CITY OF CLEVELAND

Cleveland City Planning Commission

February 20, 2026

Agenda: February 20, 2026

**DOWNTOWN FLATS ARCHITECTURAL REVIEW BOARD:
LANDSCAPE DESIGN REVIEW FINAL APPROVAL**

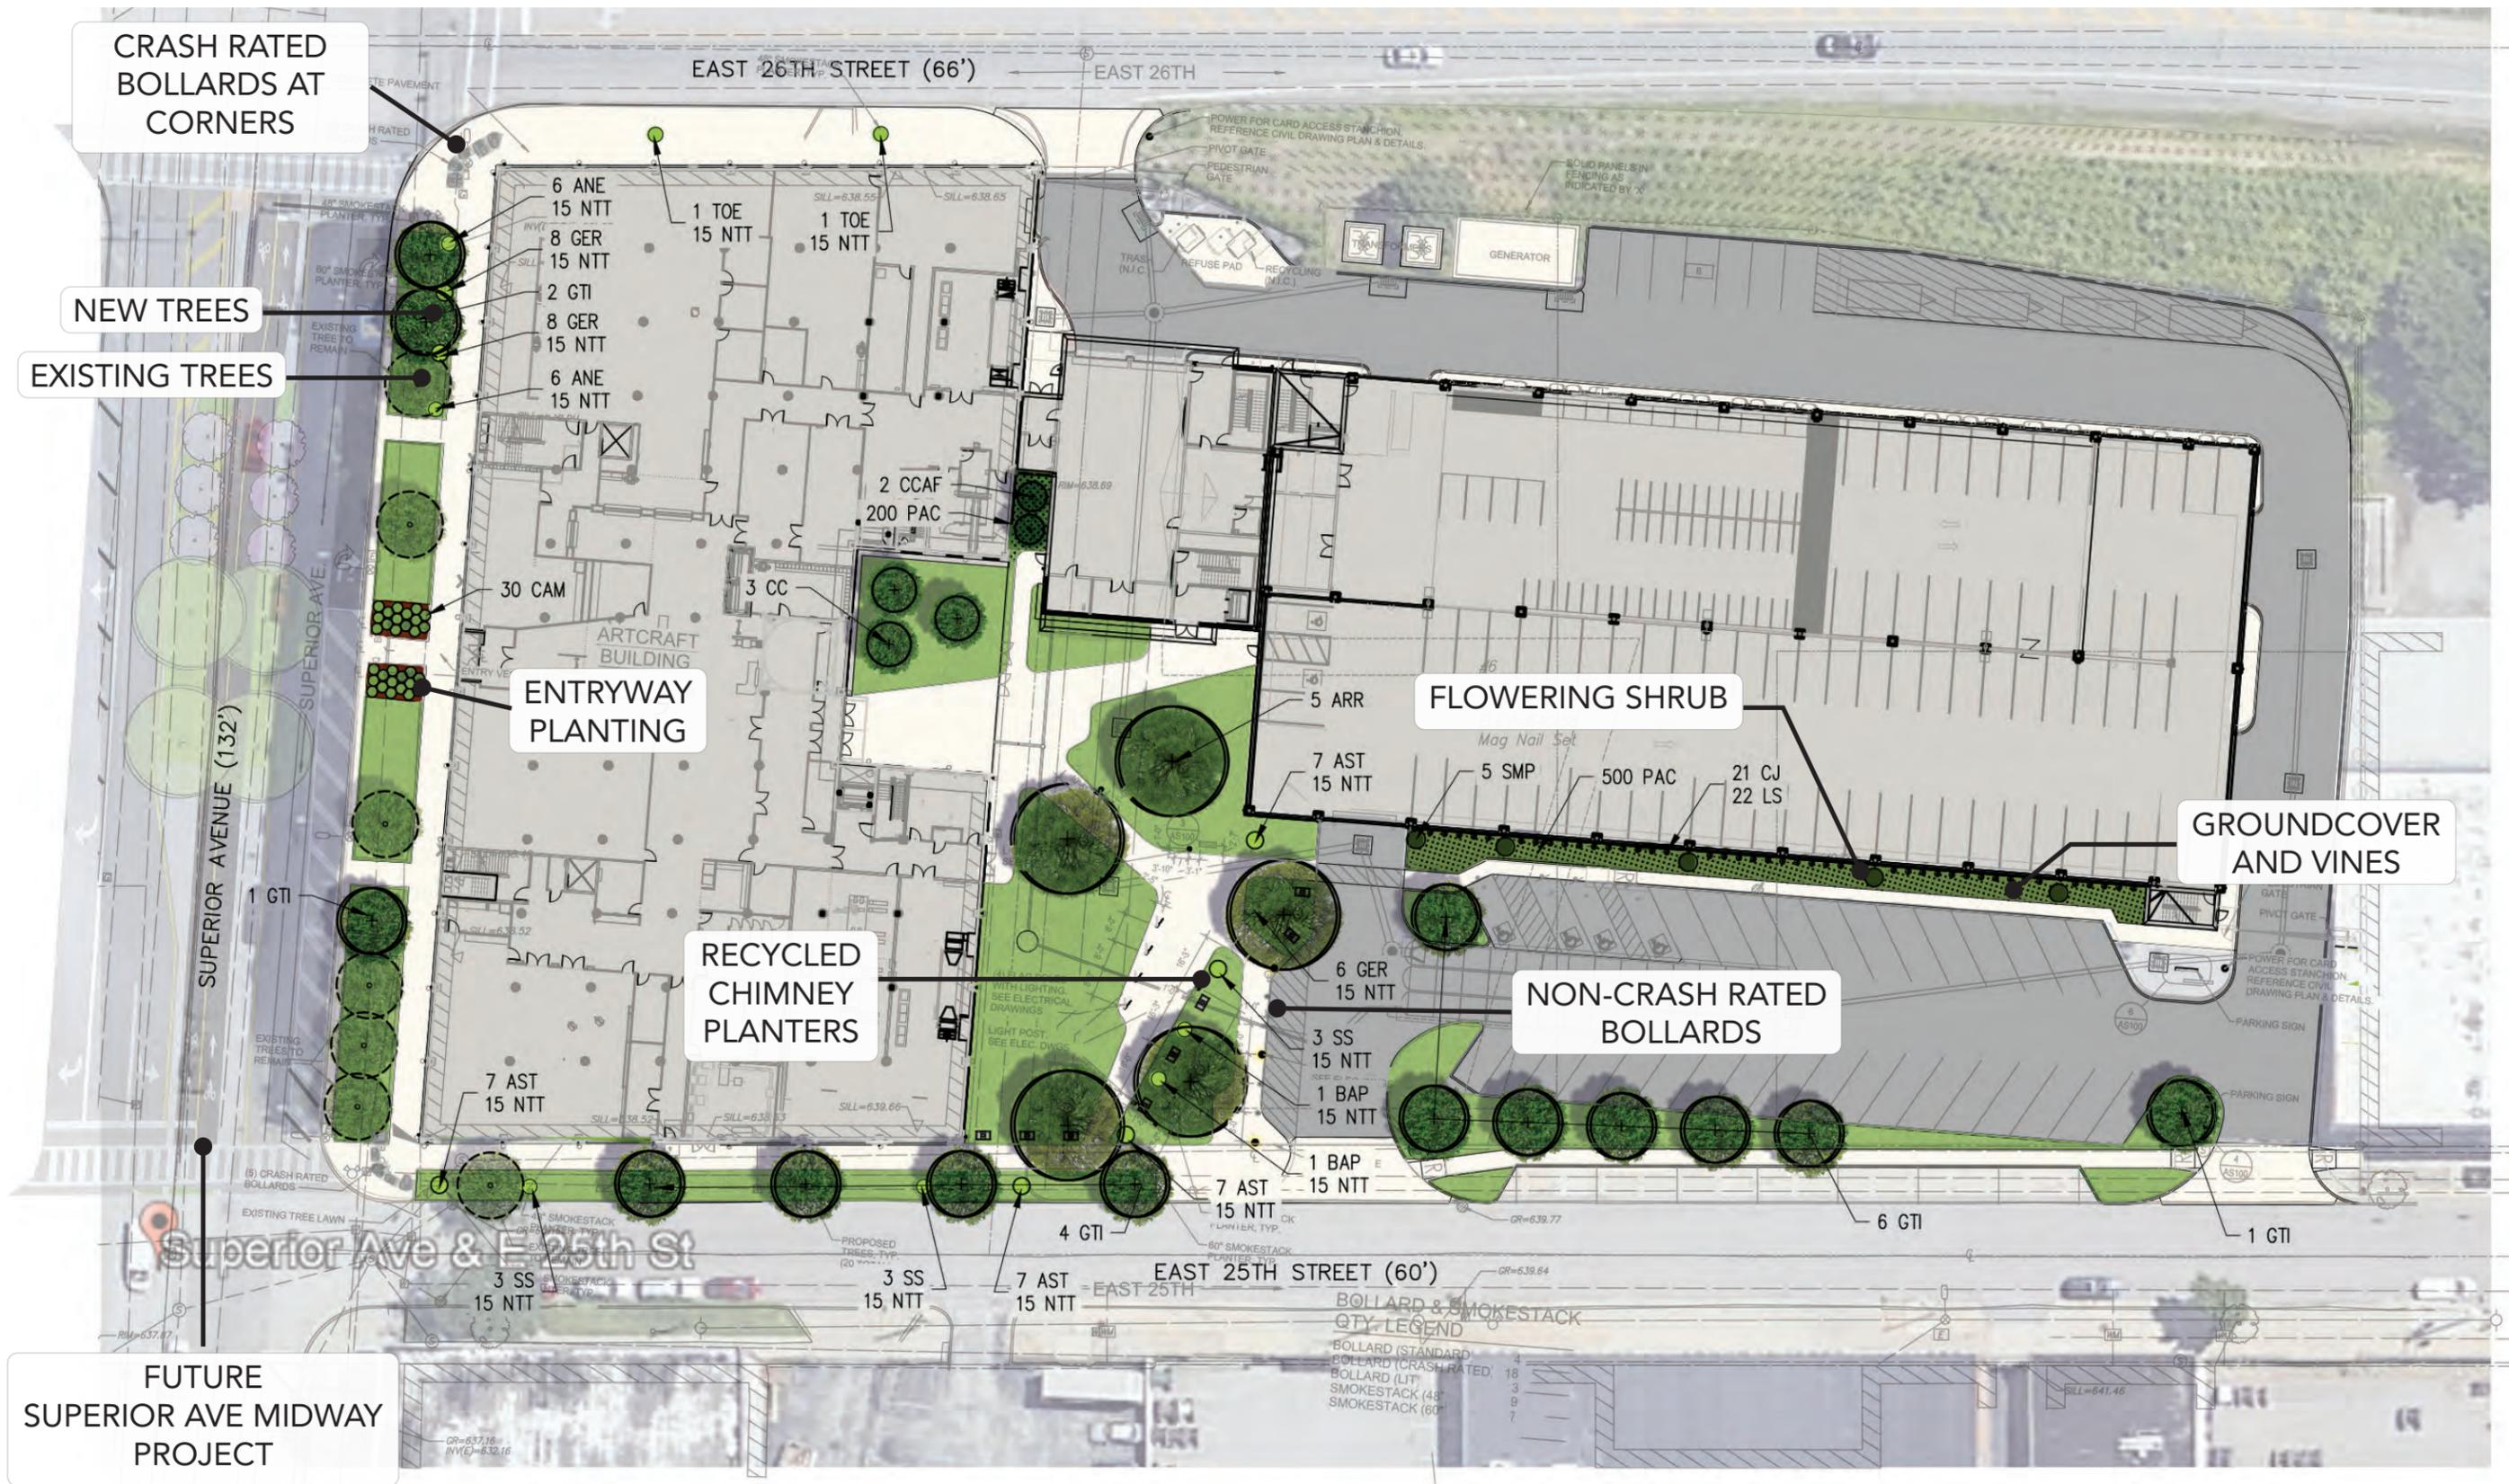
- Provide safer conditions for pedestrians along Superior Avenue with, at minimum, 18 in. to 24 in. amenity strip and 8 ft. sidewalk.
 - Review potential for improved streetscape elements including bumpouts, removal of on-street parking, and integration with Superior Midway bike land project.
 - Provide “outdoor living room” spaces within the plaza for meetings with victims.
 - Further consideration of boulders vs. bollards.
 - Review ground-plane material to alleviate maintenance concerns of trimming around each bollard/boulder
-

- **Approve** with conditions:
 - Provide additional seating in back plaza for meeting with victims
 - Reposition bollards at drop-off clear of car door swings
 - Provide additional trees wherever they do not interfere with bollards, future Public Art, or other infrastructure

PROPOSED HYDRANT LOCATIONS

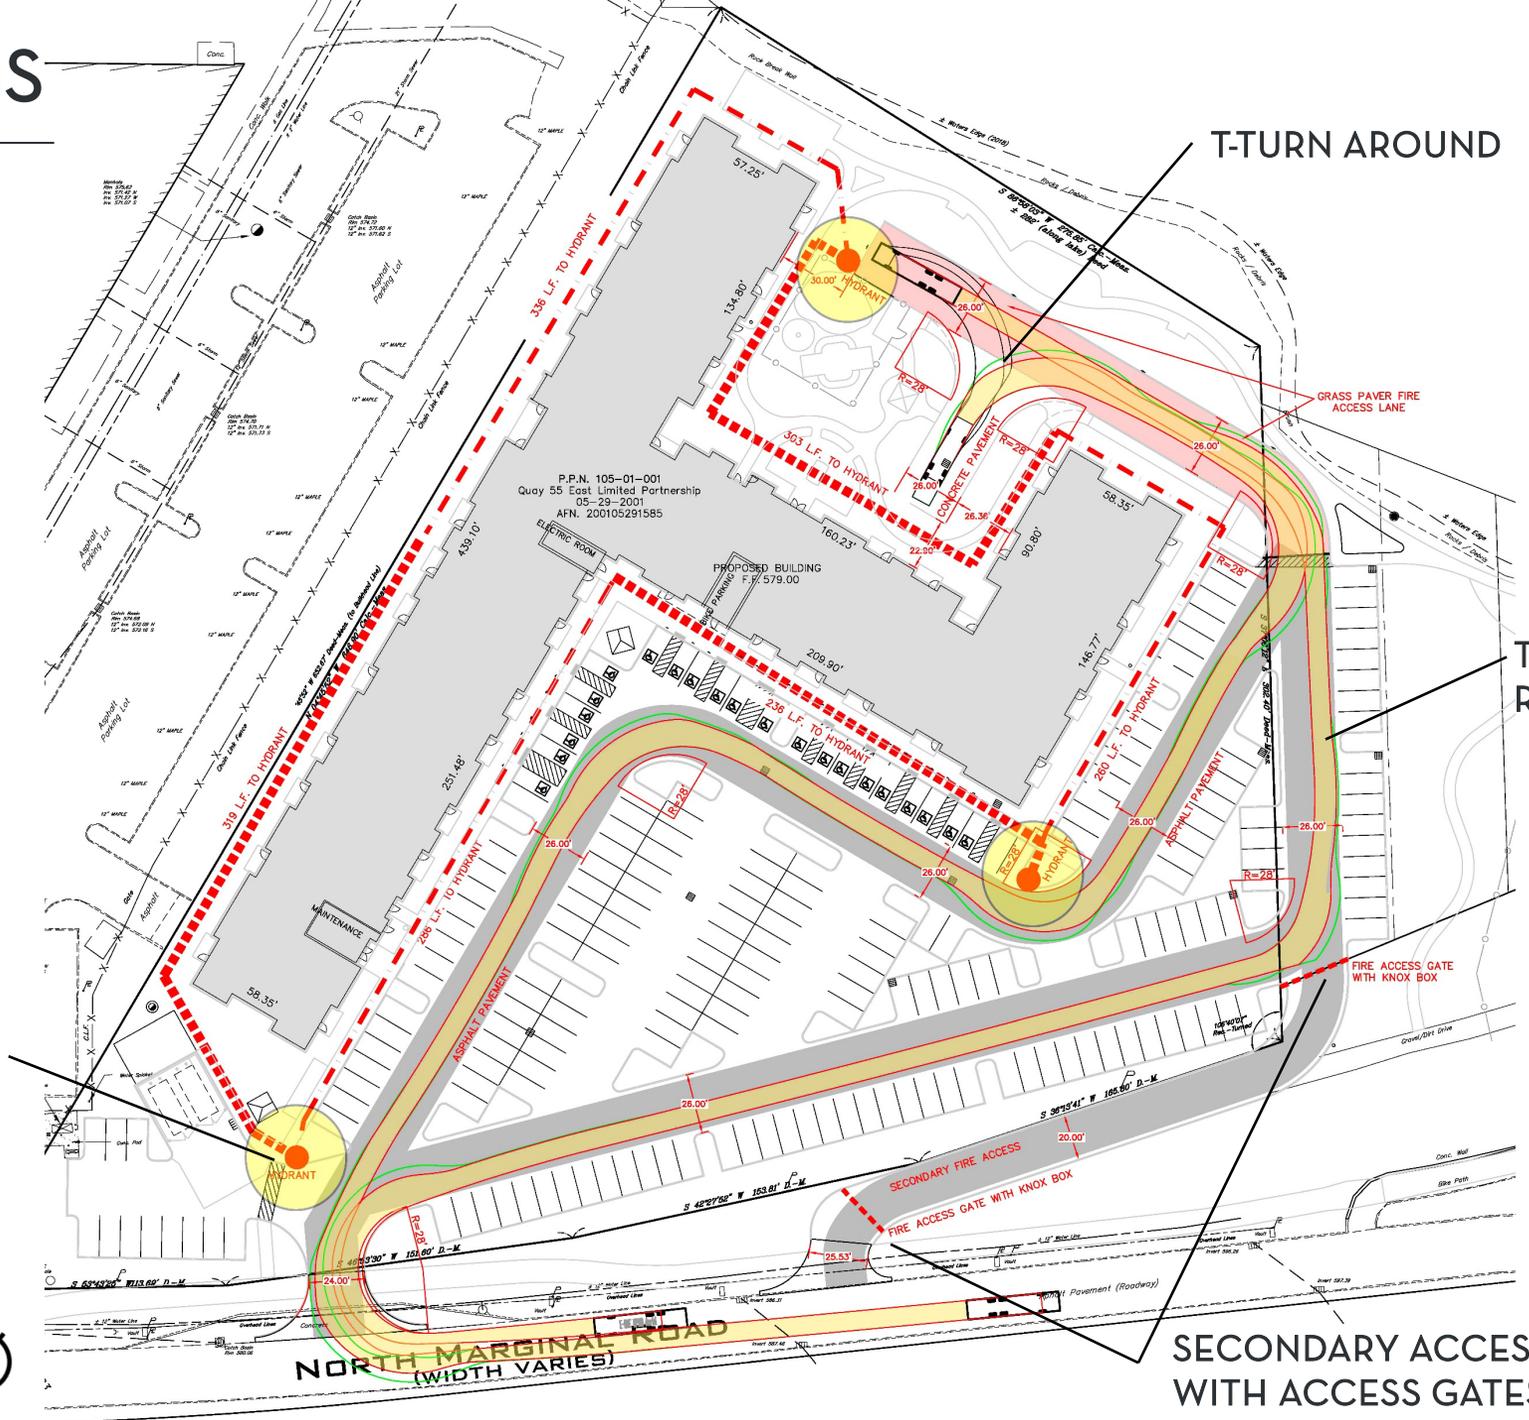
- REVISED FIRE LANE TO 24'-0" WIDTH AT PRIMARY ENTRY (FOR AERIAL APPARATUS)
- TWO POINTS OF ACCESS PROVIDED
- HYDRANTS PROVIDED ON SITE

Final Submission

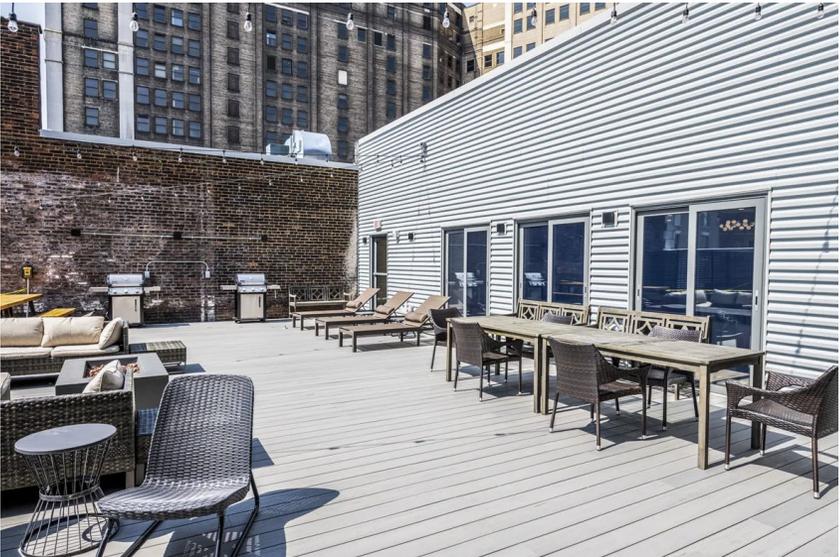
- **Final architecture & parking approved only.**
 - Final landscape/site, signage, and public park/ROW to come back.
 - Work with Staff to relocate 4 parking spots to provide adequate drop-off at front door.
- City Park Parcel & ROW design to come back
 - MOCAP/E&C Design & Permitting/Agreement Processes, NEORSD Coordination, and further develop park design (amenities, pathways & materiality, plantings, etc.)
 - Treat sewer access easement driveway more like a trail than a roadway

- **Final architecture & parking approved only.**
 - Final landscape/site, signage, and public park/ROW to come back.
 - Work with Staff to relocate 4 parking spots to provide adequate drop-off at front door.
- City Park Parcel & ROW design to come back
 - MOCAP/E&C Design & Permitting/Agreement Processes, NEORSD Coordination, and further develop park design (amenities, pathways & materiality, plantings, etc.)
 - Treat sewer access easement driveway more like a trail than a roadway

**Resolve flatness
of building** via
depth, contrast,
color, material,
and/or thickness
to create more
hierarchy and
contrast

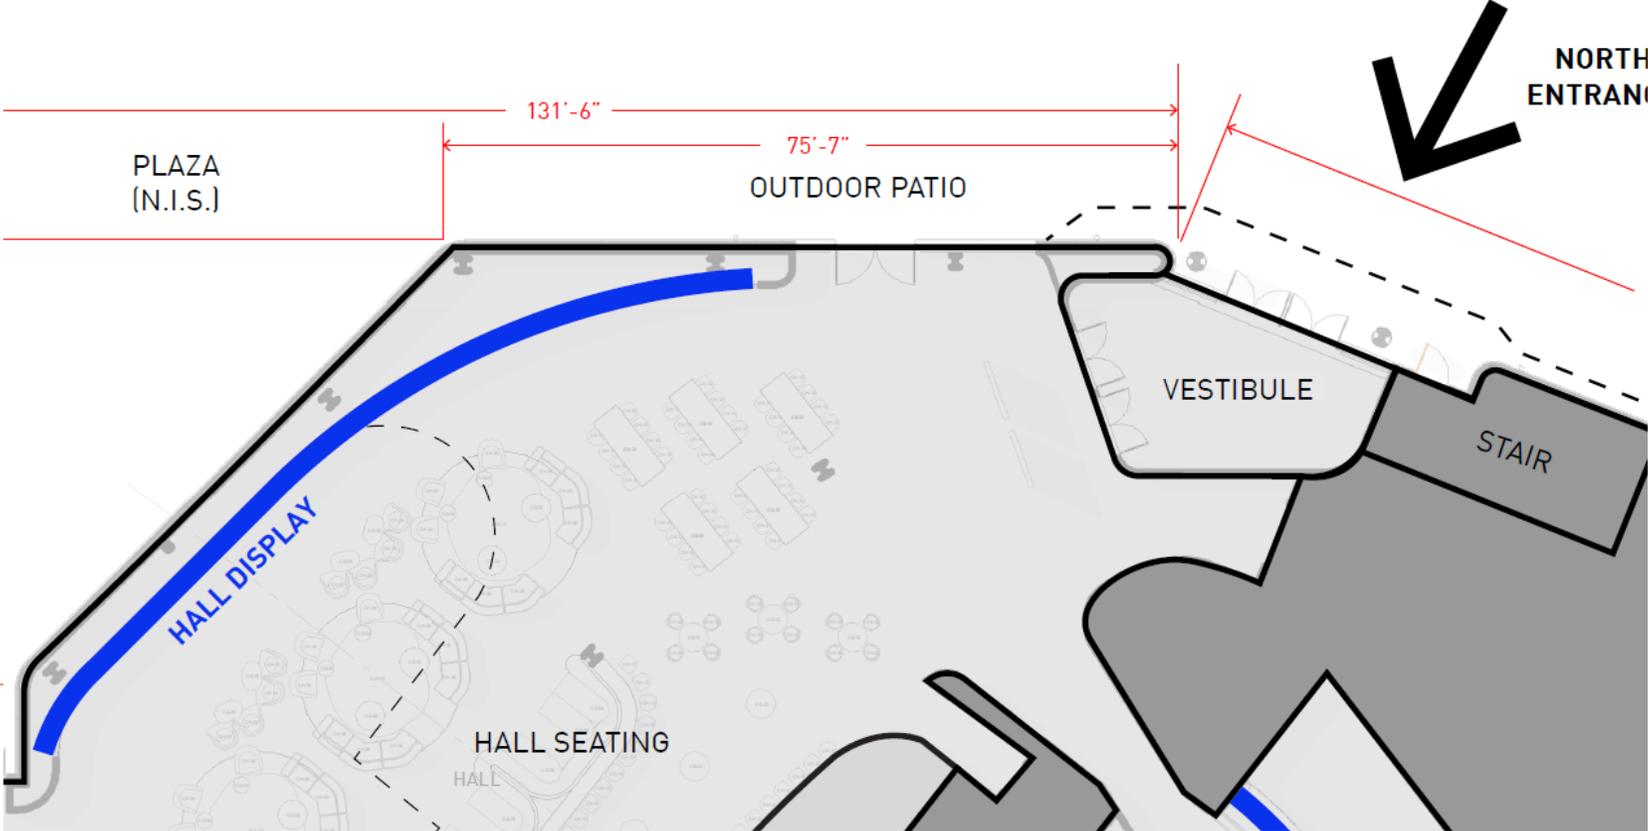
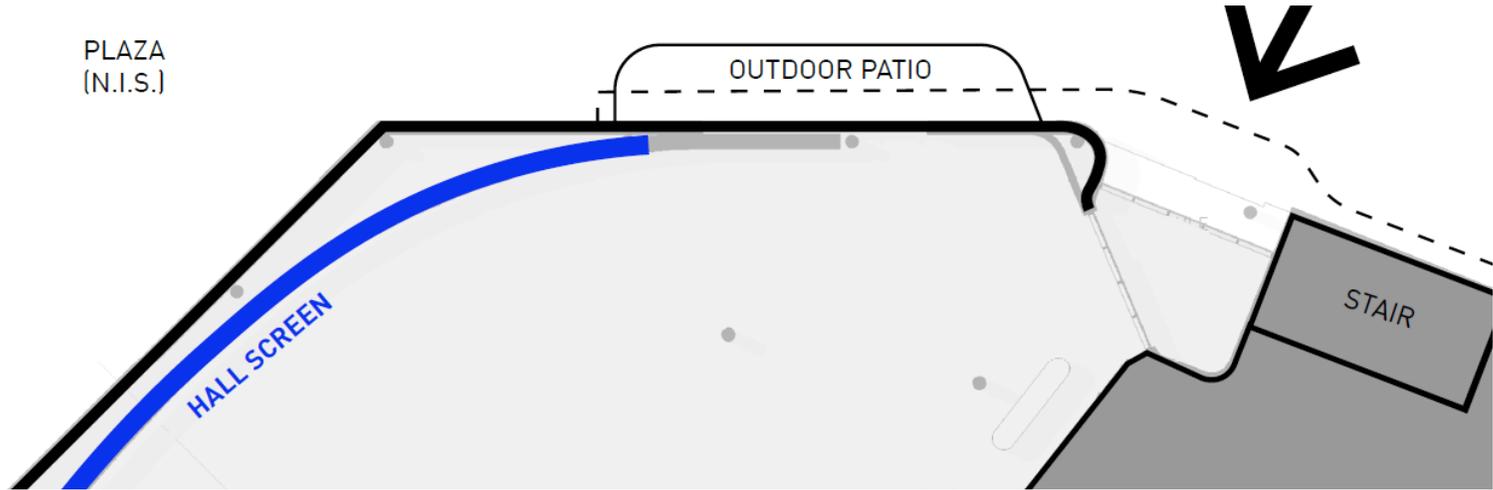
- **Final architecture approved only, with below conditions.** Site/landscape, parking, signage, & public art to come back.
 - Resolve flatness of building via depth, contrast, color, material, and/or thickness to create more hierarchy and contrast (and provide architectural lighting details).
 - Address blank walls with human-scale layering of elements especially along E. 6th walkway. Address prominence of E. 6th corner & gateway to pedestrian walkway.

Address blank walls with human-scale layering of elements especially along E. 6th walkway.

Address prominence of E. 6th corner & gateway to pedestrian walkway.

Public Art on Opaque Facades

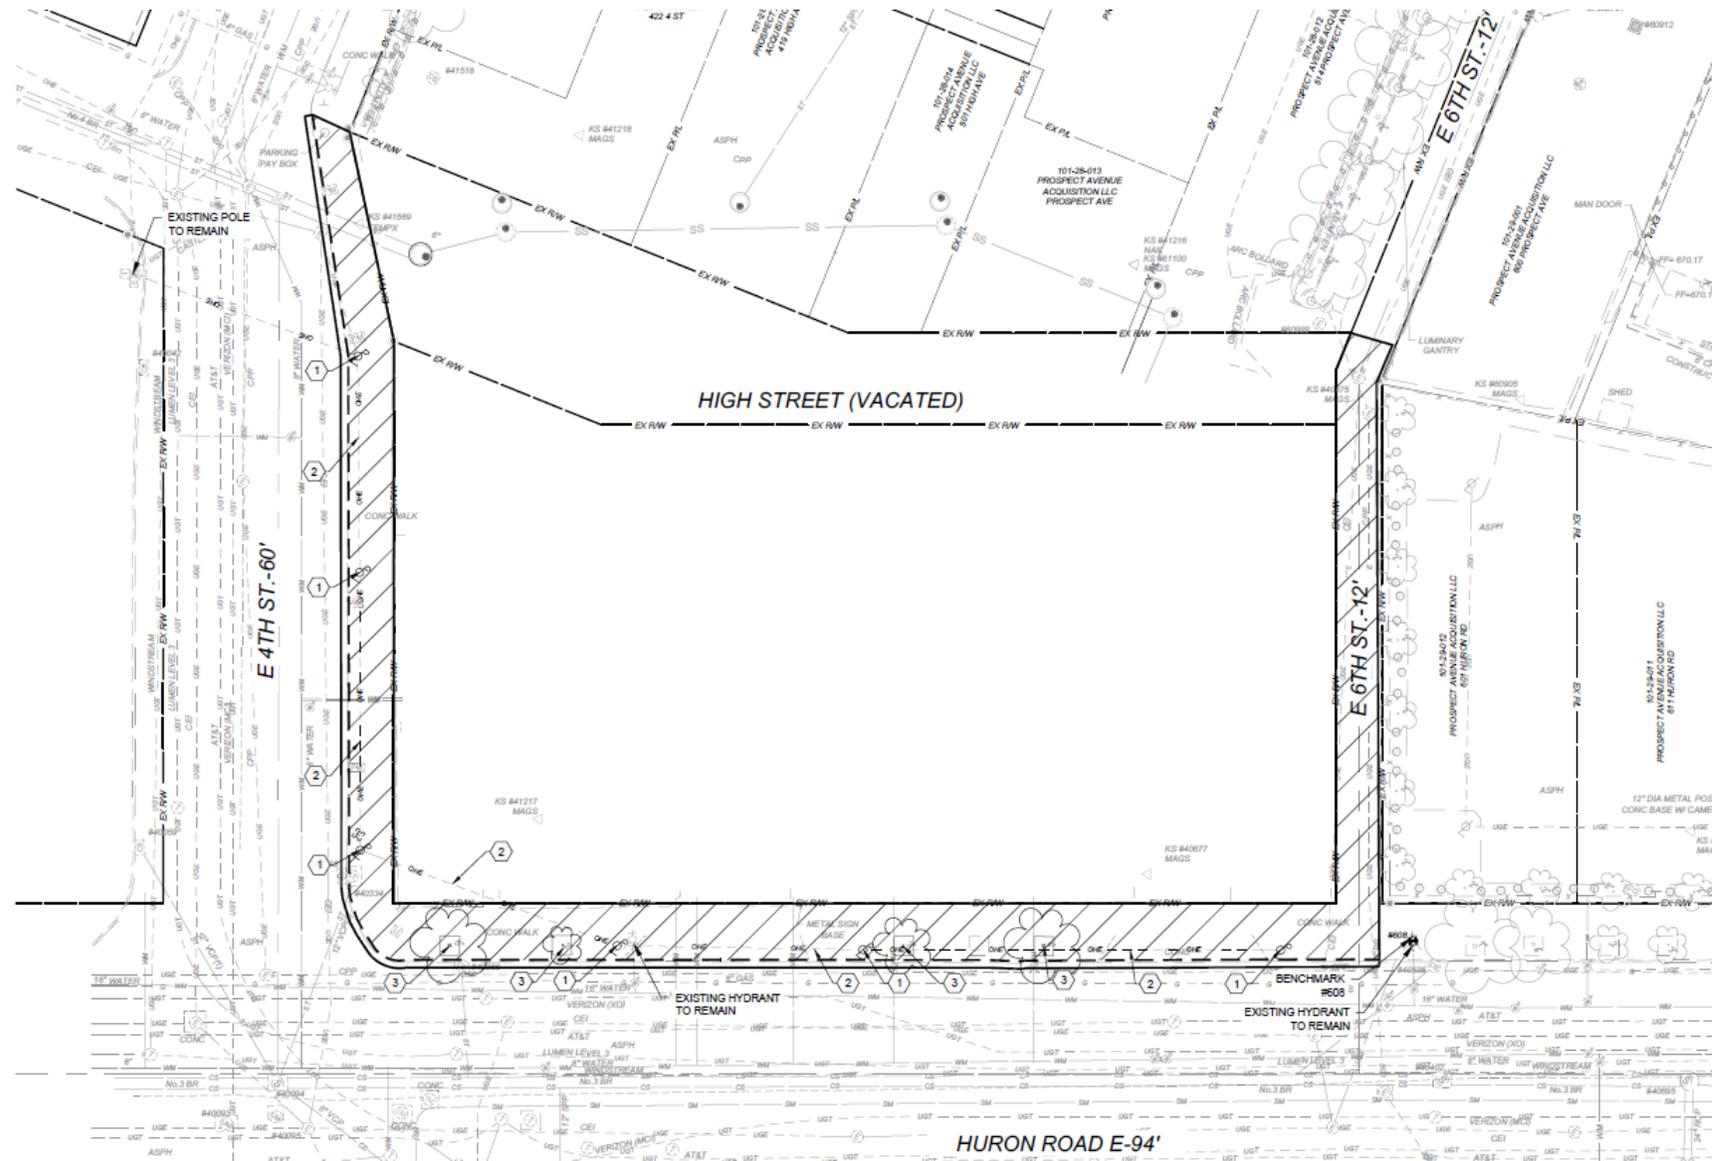
Facades active and engaging at the street-level
